**RE: NBC REQUEST FOR ADDITIONAL INFORMATION**  
**16 YEATS PLACE, KILLARNEY HEIGHTS NSW**  
Report Reference: G25021KH-R02F

**Application No. Mod2025/0158 - PAN-514889**  
**Address: 16 Yeats Avenue KILLARNEY HEIGHTS**

**Request for Additional Information**

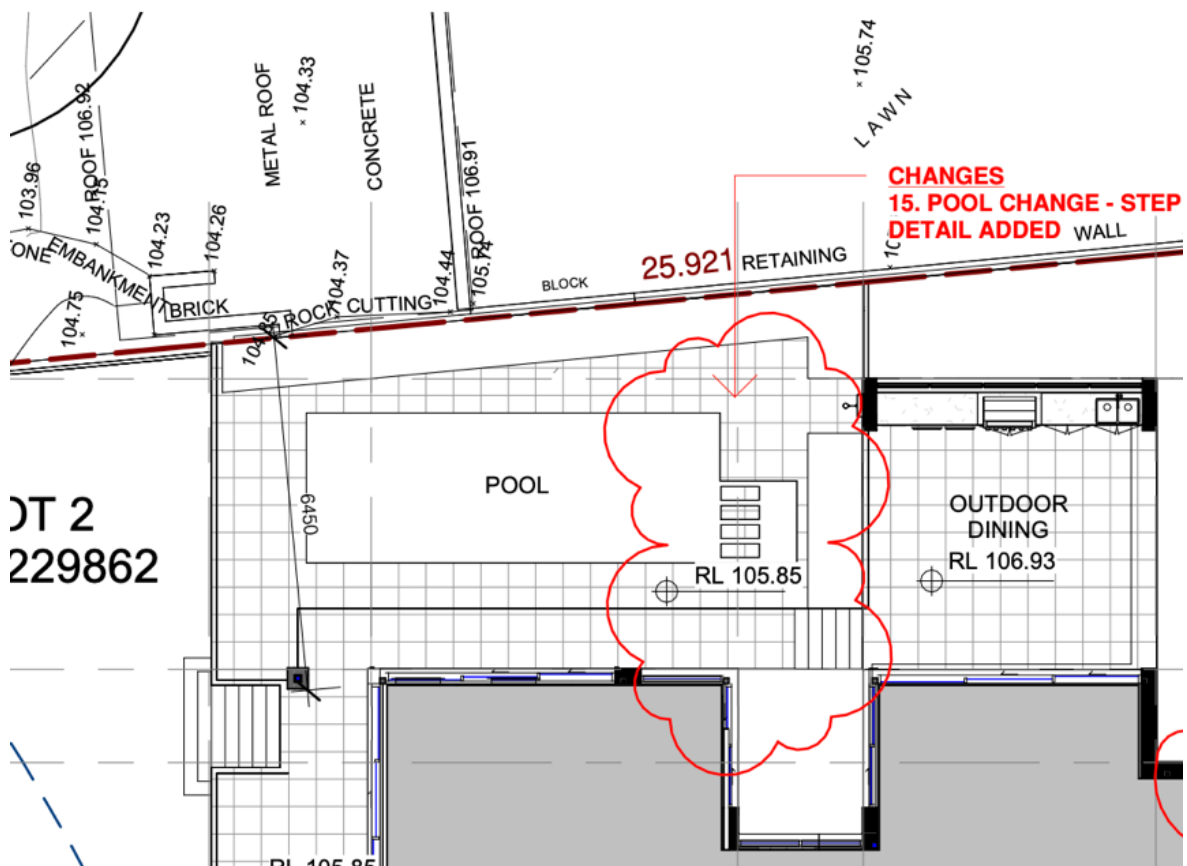
The proposed changes that have potential issues regarding the geotechnical advice include a minor extension in the excavation footprint for the proposed swimming pool. It is noted that this is expected to include an additional 0.30m of excavation for the steps of the pool.

Matthew Kilham from GEE inspected the site on the 9<sup>th</sup> April 2025 and this inspection was related to an inspection of the exposed ground conditions around the proposed swimming pool area. At the time of the inspection the swimming pool footprint had been partly marked out with saw cuts into the cropping sandstone bedrock.

The rock excavation based on the adjacent excavations is expected to encounter fine to coarse grained, medium to high strength Sandstone bedrock. The excavation is expected

to leave a plinth of exposed sandstone bedrock approximately 1.20m in width, 1.20m in height and 4.0m in length adjacent to the carport of No.14 Yeats Place.

- ◇ A dilapidation summary of the adjacent carport on No.14 is recommended with engagement of the owners as the close proximity of the excavation is expected to cause some disturbance of the adjacent structure. For example, loose or detached items on shelves or in cupboards may be become displaced, items in proximity to the exposed batter will need to be moved or protected. Due to the nature of the adjacent structures, vibration monitoring is considered to be optional, but is recommended as a general practice to ensure the excavation works have been carried out in a reasonable manner designed to reduce the impact of the vibrations on adjacent structures.
- ◇ A smaller rock hammer <150kg is recommended to reduce the impact of the vibrations which should be kept at 5mm/sec. All other rock excavation recommendations as noted in 'Davies' report should be adhered to.

- ◇ The exposed sandstone bedrock batter in No.14, approximately 1.20m in height could not be assessed at the time of the site visit. As an exposed rock plinth 4.0L \* 1.20H \* 1.20W is expected to remain, it is recommended that this is inspected to ensure there are no loose blocks that may detach during the proposed excavation works. Additionally, the batter could be protected with matting to catch any smaller loose rocks that may detach during the excavation.
- ◇ At the completion of the works the stability of the plinth should be assessed. Some minor works may be required to ensure it's longer-term stability.
